Our Ref: 20EMKC02 / 18AWE02:NvD/JT
DoP ref: SSD 9741
NSW RFS ref: D18/9741-Mod-1

**Re: Lane Cove Data Centre – summary of changes for resubmission /
Addendum Bushfire Protection Assessment
1 Sirius Road, Lane Cove West**

Travers bushfire & ecology has been requested to provide a revised bushfire assessment to address the latest modifications to the State Significant Development (SSD) approval for the Lane Cove Data Centre.

Figure 1 –Masterplan (schedule of changes)

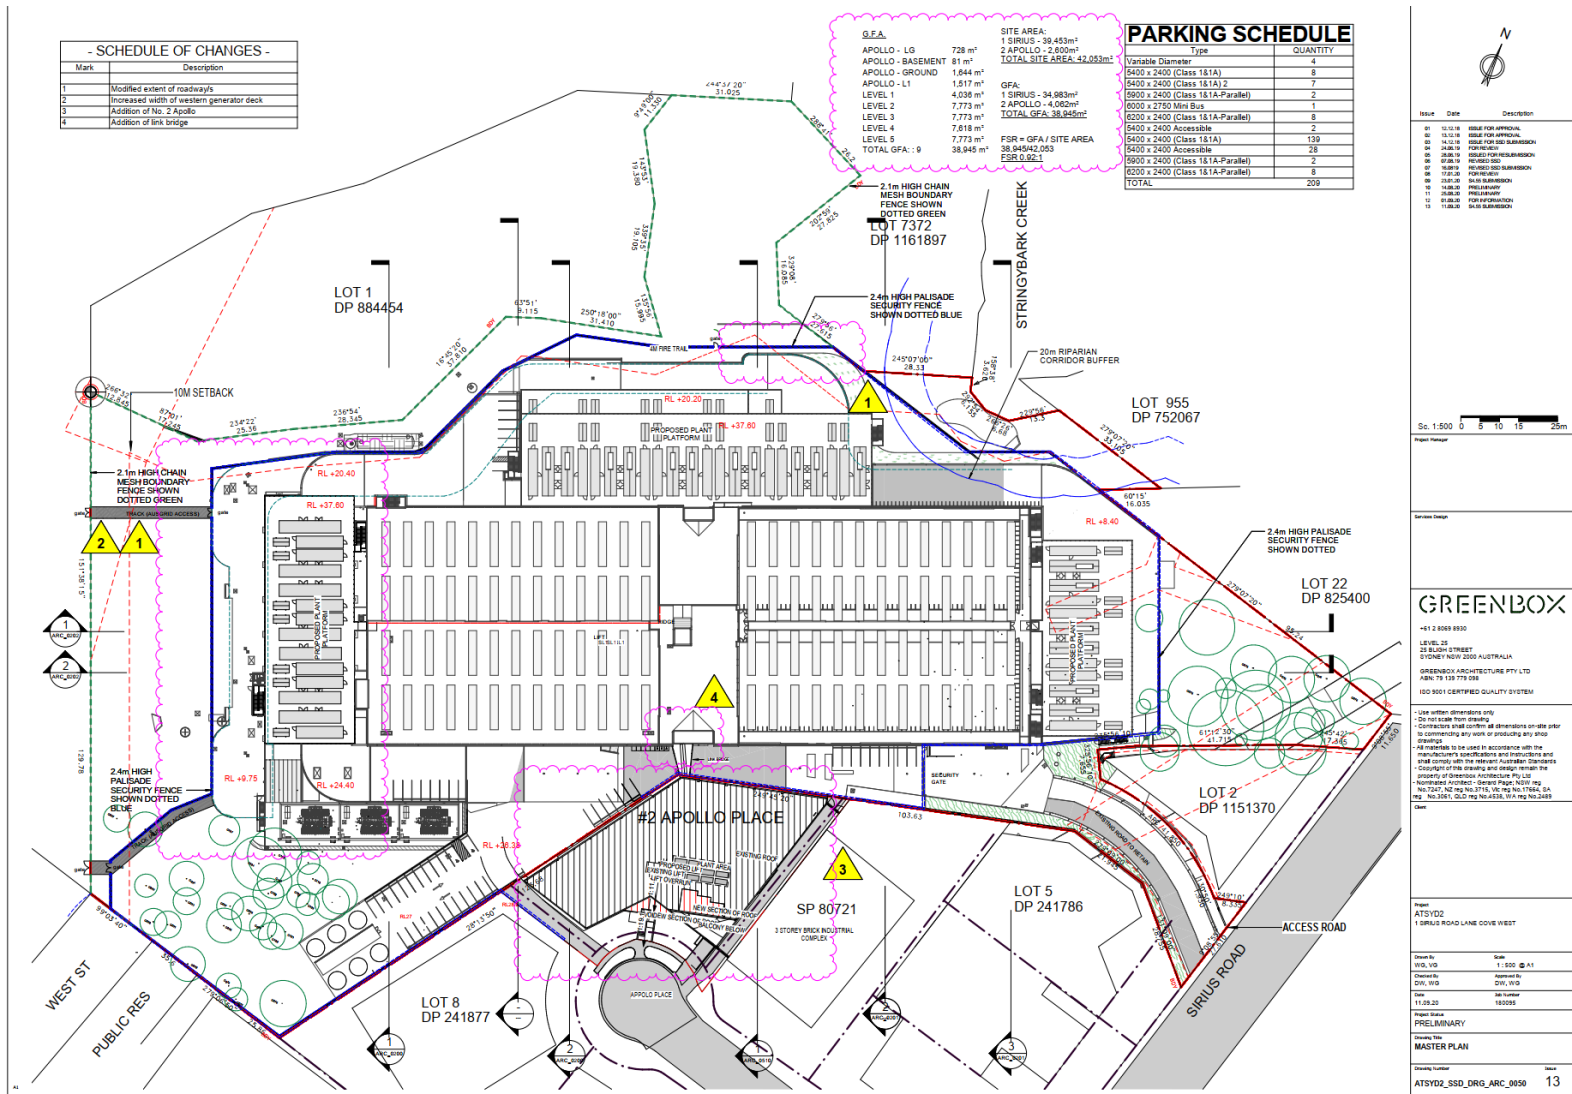
This revised assessment is based on the follow proposed changes to the scheme (as depicted in Figure 1);

- Modified extent of fire trail (as depicted in red in Figure 1). This increases the road width in two (2) locations;
- Reconfigured substation (slight amendment to footprint);
- Plant and equipment gantries have been extended (Generator Platform 2 & 3) to provide sufficient clearance around plant equipment; and
- Addition of 2 Apollo Place (office building) and the addition of a link bridge between the office building and the data centre; and
- Minor changes to landscaping to reflect modified extent of roadways.

The changes to the fire trail design is provided in Figure 1. As depicted in red the proposal will increase the road width in two (2) locations.

Schedule 1 - Bushfire Protection Measures

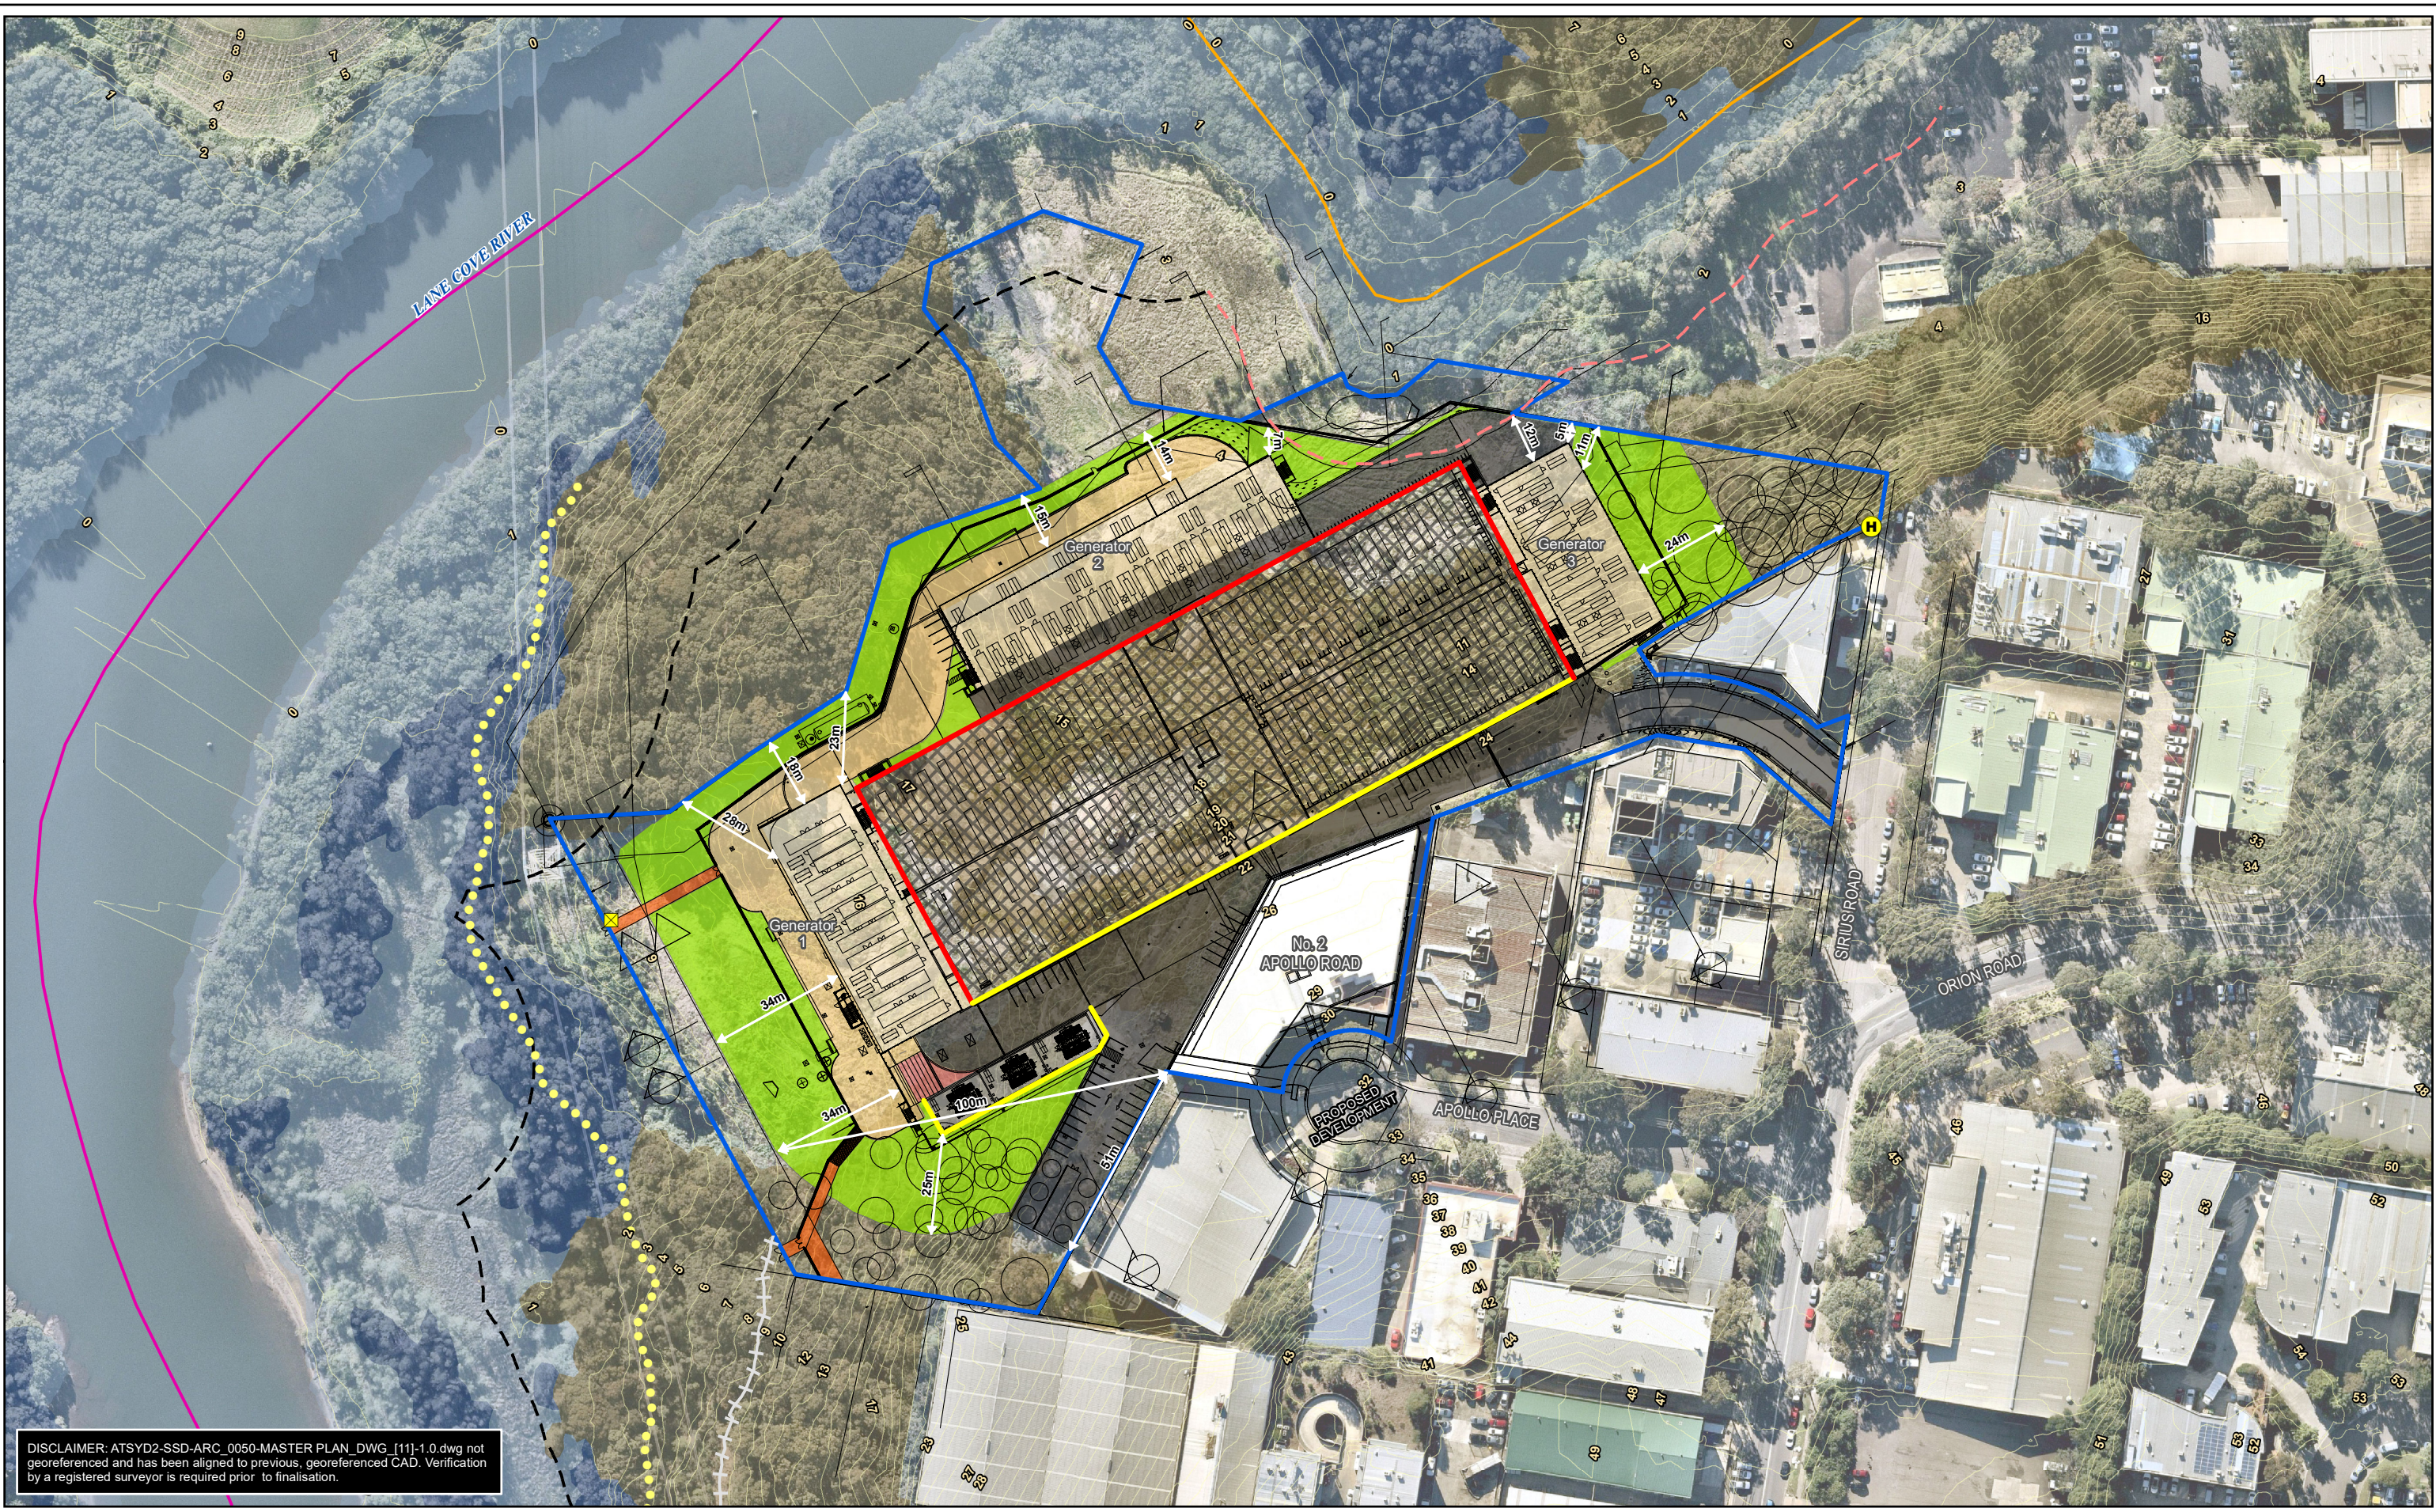
The revised scheme maintains the same data centre building footprint and height. However, the external generator platforms have been amended and the footprint area has increased slightly (i.e. Generator Platforms 2 & 3 – the plant and equipment gantries have been extended closer to the northern & eastern site boundary). In addition the existing building at 2 Apollo Place has been incorporated into the scheme for use as an office building. This building is afforded adequate separation from the bushfire hazard to avoid significant radiant heat attack.

As a result of the revised scheme, the APZ dimension has been amended (as depicted in bold) to reflect the new platform locations / extent as depicted in Schedule 1 – Bushfire Protection Measures attached and as follows.

Whilst the platform locations have been amended and are located closer to the site boundaries (in some cases) the APZ footprint remains the same, as per the previous design, and will not impact on any bushland areas proposed to be retained on site.
